March 24, 1982
TAAG-0008

ASSESSMENT OF DEFUELING PLAN

FOR THREE MILE ISLAND, UNIT 2

III. COMMENTS ON BECHTEL NATIONAL'S TECHNICAL PLAN FOR REACTOR DISASSEMBLY
AND DEFUELING REVISION 2, DATED JANUARY 1982

FIGURE II-1 LOCATION OF CONTROL ASSEMBLIES

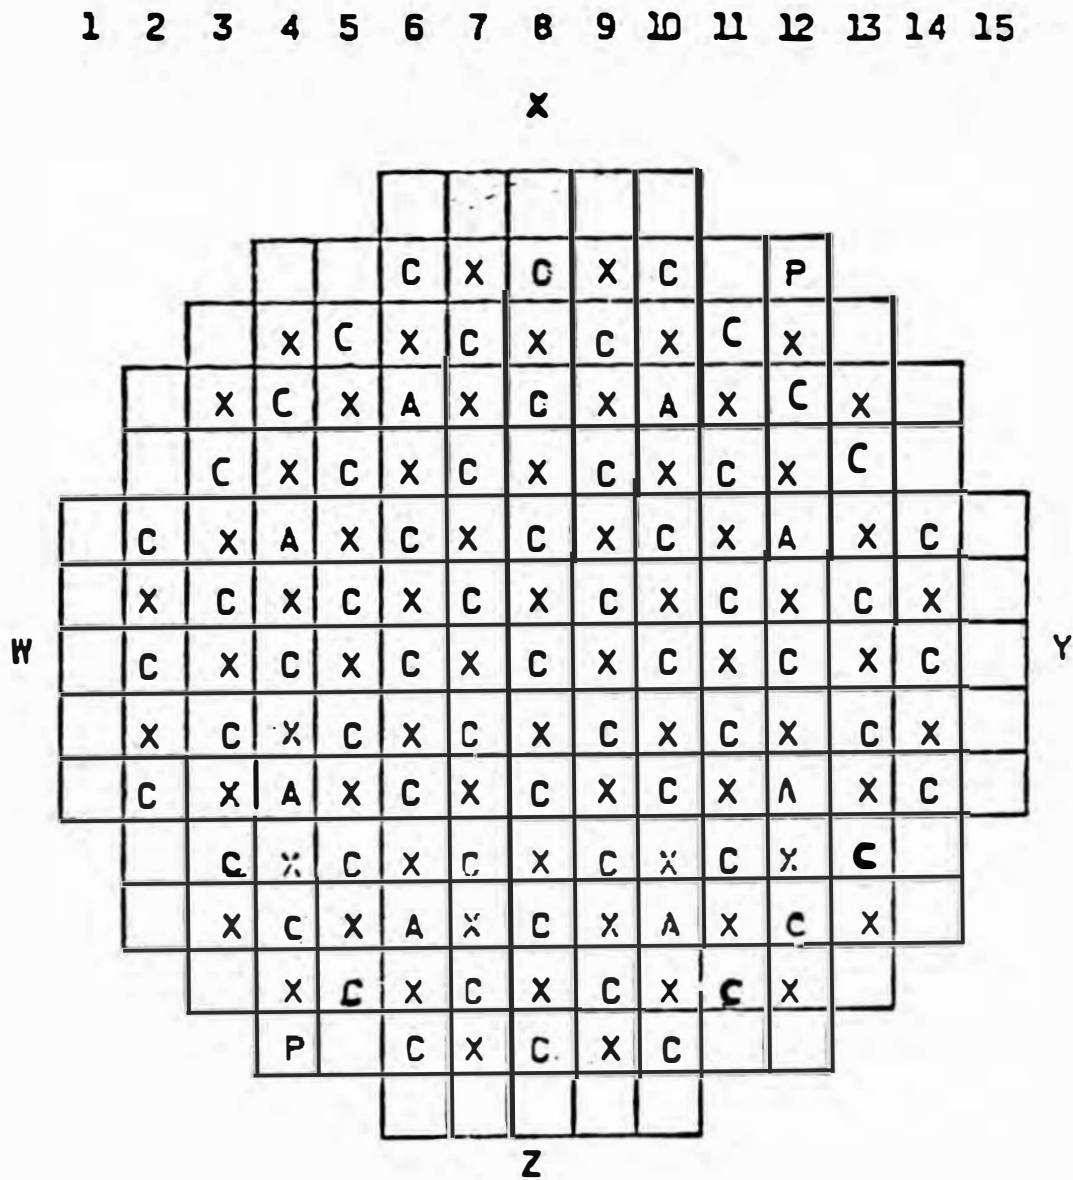
In addition to providing the above information these tests will be used to position the APSR rods in the fully inserted position specified in Step C12 of the "Technical Plan for Reactor Disassembly and Defueling"

(TPO/TMI-005). Should these tests from outside the reactor building be successful, their accomplishment from outside the reactor building will reduce the radiation exposures and eliminate steps now planned to be done on the ASPR's from inside the reactor building.

3. In the early part of the plan, several steps contain a number of activities that apparently could be accomplished from outside the reactor building (e.g., electrically checking the Axial Power Shaping Rods). Radiation doses would be reduced and any information developed would be available at an earlier date for planning of the defueling. Although this same activity may be conducted early from outside the reactor building as part of a "quick look", it also accomplishes a portion of the technical plan.

FIGURE II-4 LOCATION OF FAILED LEVEL 1 SPND'S

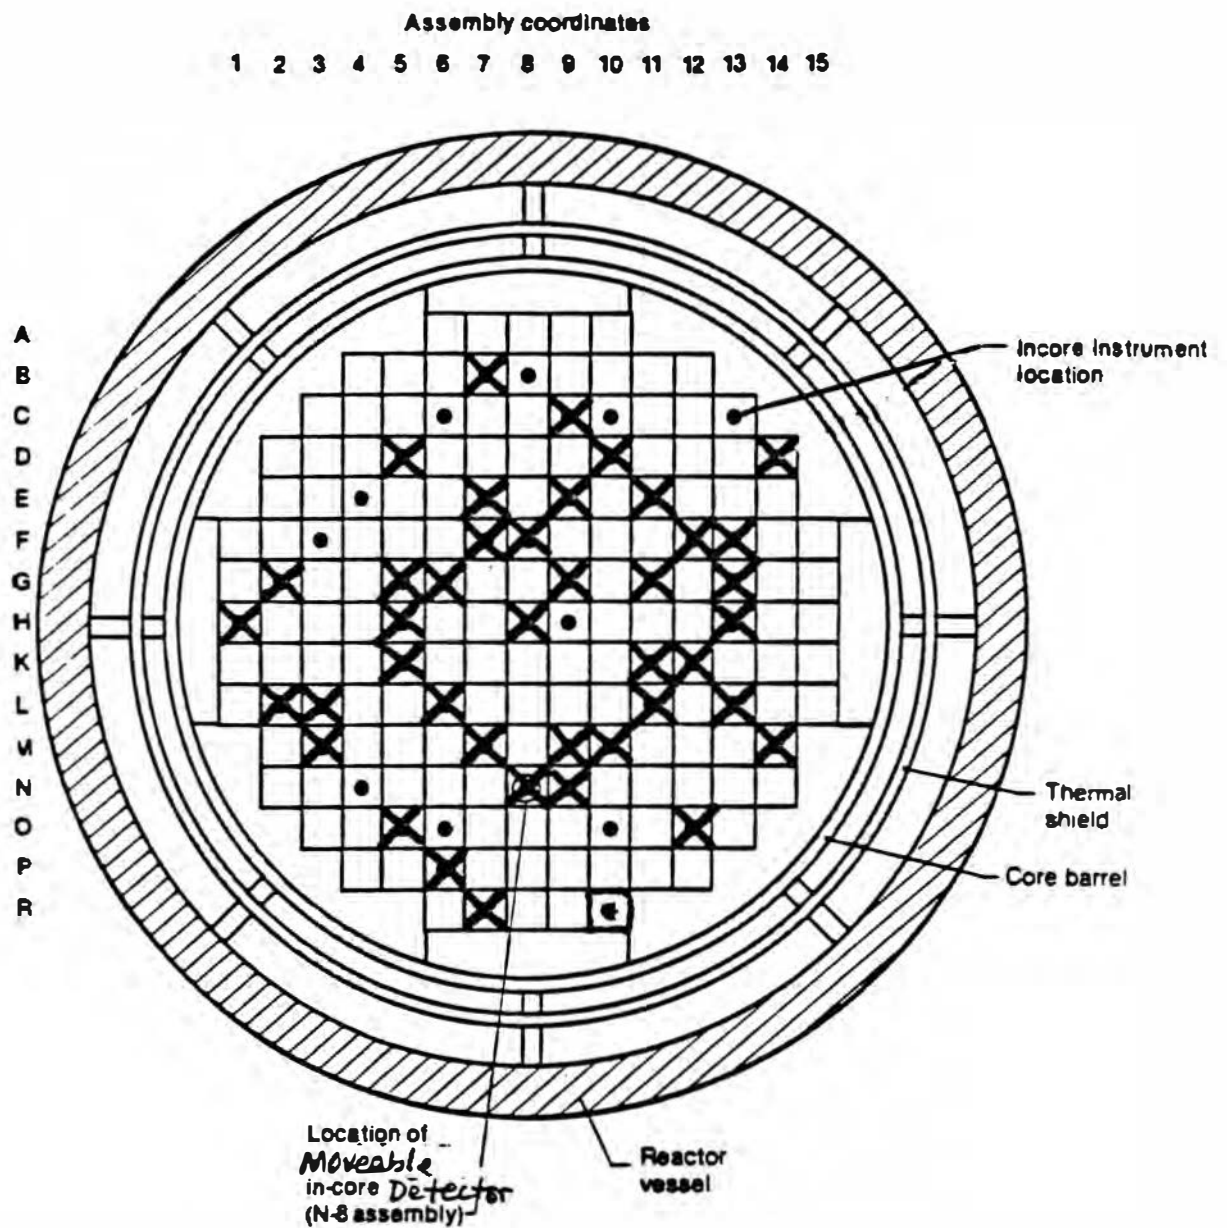
Similarly the measurements that showed the failure of most SPND's within several days after the accident should be interpreted as an indication of damage in core areas such as peripheral fuel assemblies and near the core bottom. Figure II-4 shows the locations of detectors that failed at the lowest level in the core.

FIGURE III-1 DEFUELING IN CANAL CONTAINMENT
68

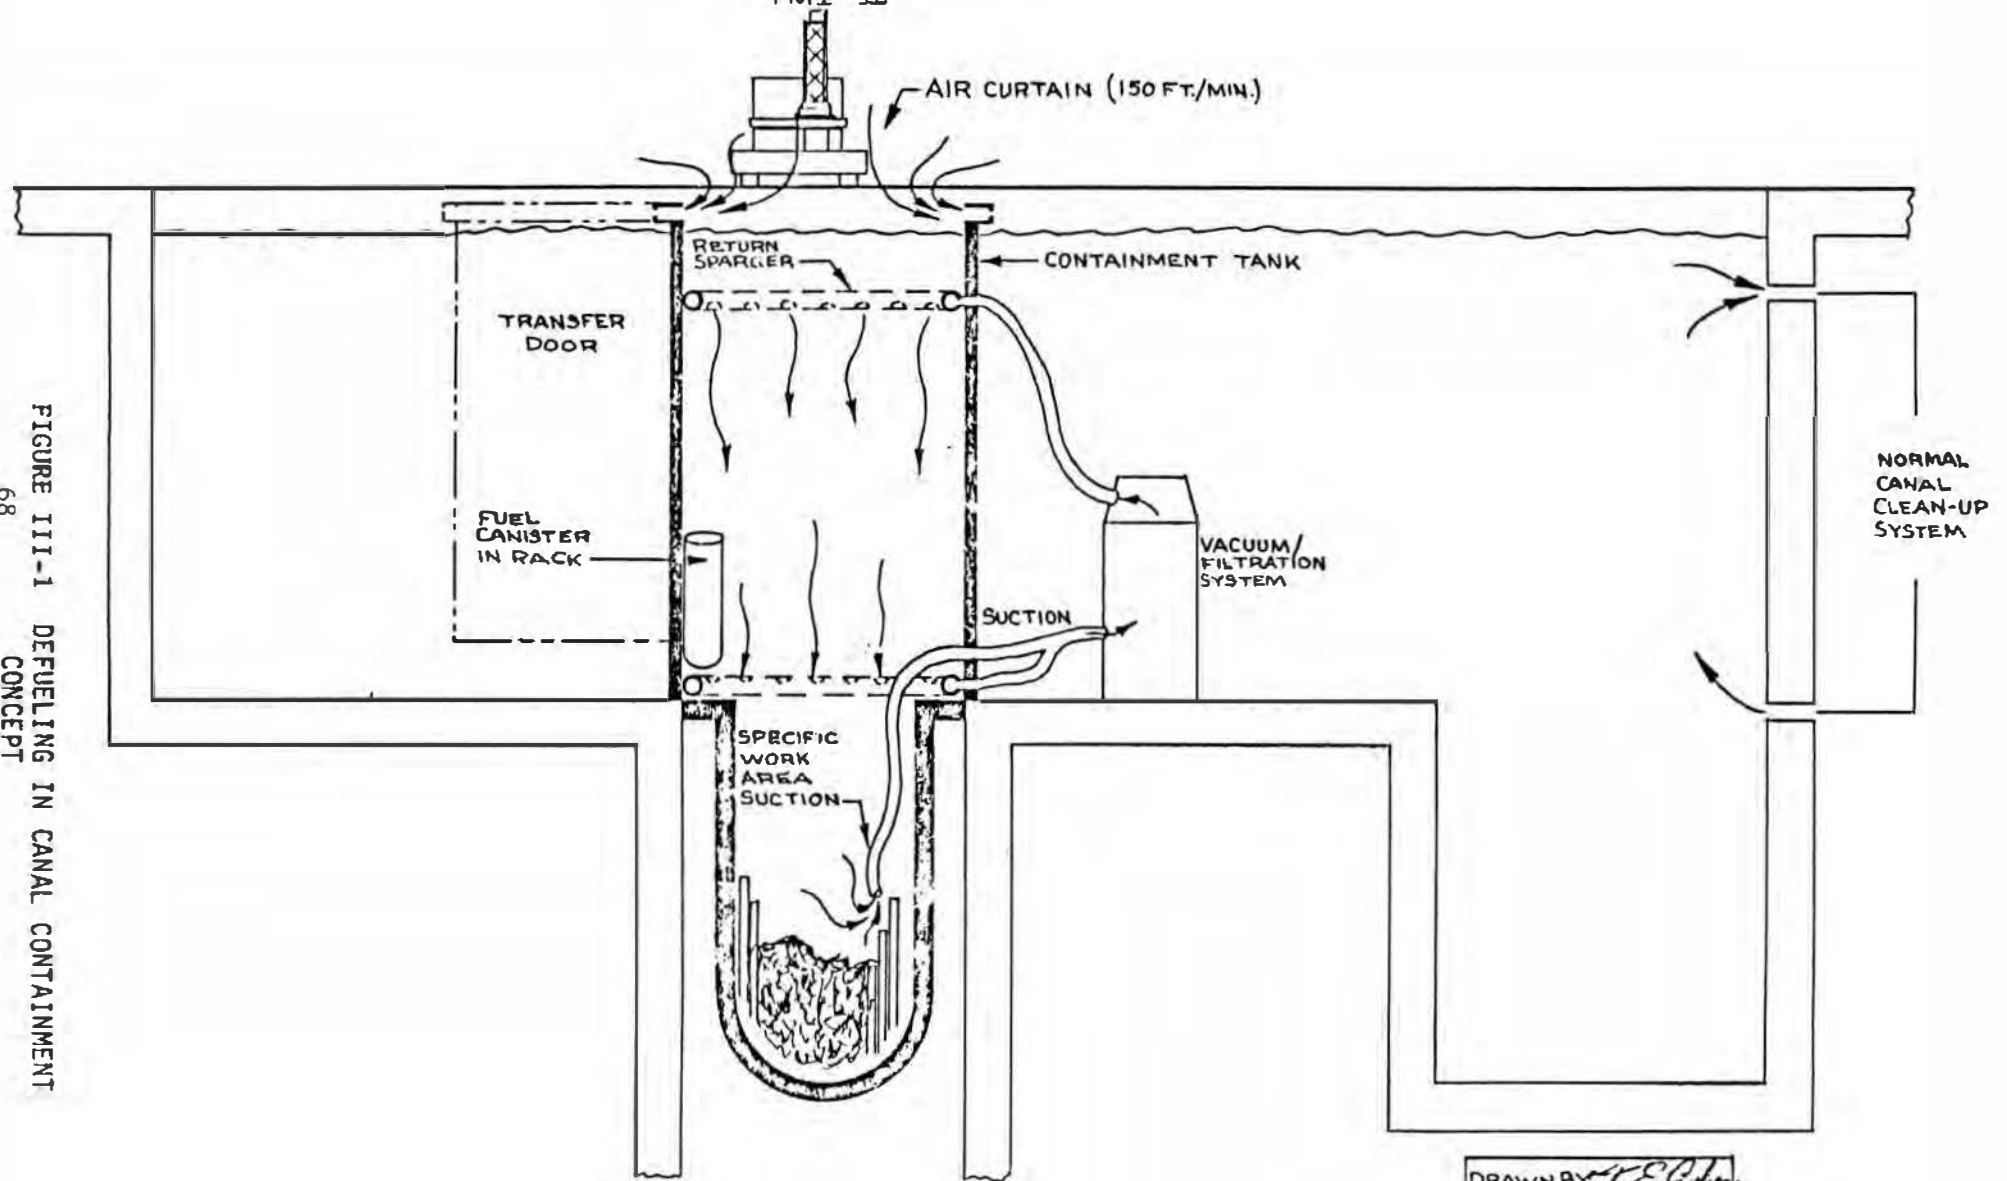
E.3 This step briefly mentions "physical barriers" to minimize contamination spread to be discussed in G.15 (non existent). A concept is provided in Figure III-1 which utilizes a "refueling tank" type barrier coupled with water and air moving equipment designed to catch material at its source and minimize the amount of high activity water which must be processed. This unit would be installed prior to flooding the canal and must accomodate operations such as plenum jacking.

- E.4 See comment relative to D.4.
- E.8 See comment relative to physical barrier in E.3.
- F.5 It does not appear necessary to perform the "small initial lift" of the plenum - recommend a higher lift and commence with the video camera viewing.
- F.5 2.1 There should be no option regarding the test of the plenum lifting lugs if they are to be used.
- F.6 Plenum jacking - The criteria for the use of jacking devices and vertical impacting equipment has to be carefully established. The interaction of these devices on the polar crane are of particular concern. Also the criteria needs to be established as to when to go to plenum removal by dismantling the plenums.
- F.10 Consideration should be given to providing a physical barrier around the plenum (underwater) so that subsequent operations such as decon, inspection, etc. do not transfer large quantities of contamination into the canal.
